Access Compliance Report

Public Rights-of-Way

(Curb Ramps)

Intersection ID: 47106	Main Street: RUTH_POLK_CT	Cross Street: ERNEST_RUSSELL_CT	Location: S
ADA ID: 75929B582FAE	Ramp Type: PerpDiag	Initial Pass/Fail: Fail	Overall Compliance: No
Severity Score: 22.5			
Codes/Mitigation Info/Possible Solution		Field Measurements/Component Compliance

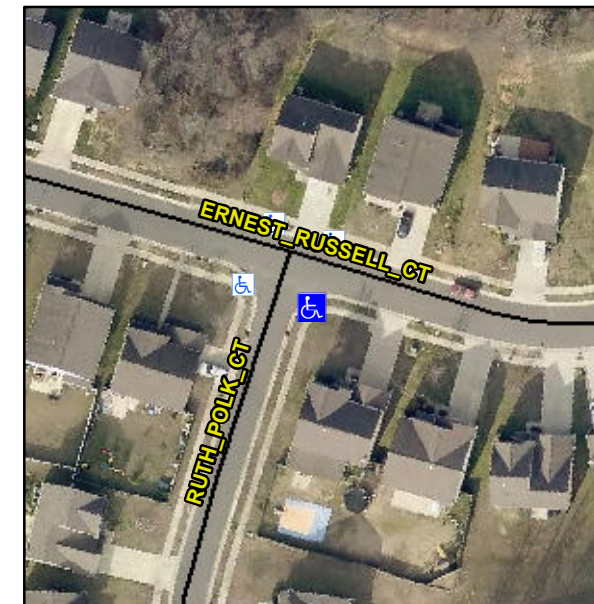
Not Found, R304.5.1, R304.2.2, R304.5.3

Compliance	Description	Data	Compliance	Description	Data
N/A	Ramp Length (in)	49.0	No	Ramp Slope (%)	9.5
No	Ramp Width (in)	40.0	No	Ramp XSlope (%)	2.5
N/A	Flare Type LT	N/A	N/A	Flare Type RT	N/A
N/A	Flare Slope LT (%)	N/A	N/A	Flare Slope RT (%)	N/A
N/A	Flare Traversable LT?	N/A	N/A	Flare Traversable RT?	N/A
N/A	Landing Length (in)	N/A	N/A	DWS Provided?	N/A
N/A	Landing Width (in)	N/A	N/A	DWS Contrast?	N/A
N/A	Landing Slope (%)	N/A	N/A	DWS Length (in)	N/A
N/A	Landing X Slope (%)	N/A	N/A	DWS Full Width?	N/A
N/A	Landing Curb? (Y/N)	N/A	N/A	DWS Offset (in)	N/A
N/A	Shared Landing?	N/A			
N/A	Gutter Ponding?	N/A	N/A	Gutter Slope (%)	N/A
N/A	Gutter Lip Ht (in)	N/A	N/A	Gutter X Slope (%)	N/A
N/A	Painted X Walk1?	No	N/A	Painted X Walk2?	No
	X Walk 1 Direction	To NE		X Walk 2 Direction	To NW
N/A	X Walk 1 Width (in)	N/A	N/A	X Walk 2 Width (in)	N/A
	X Walk 1 Slope (%)	1.6		X Walk 2 Slope (%)	1.2
	X Walk 1 X Slope (%)	1.0		X Walk 2 X Slope (%)	1.6

Remove & Replace Curb Ramp With Two New Directional Ramps or Equivalent.
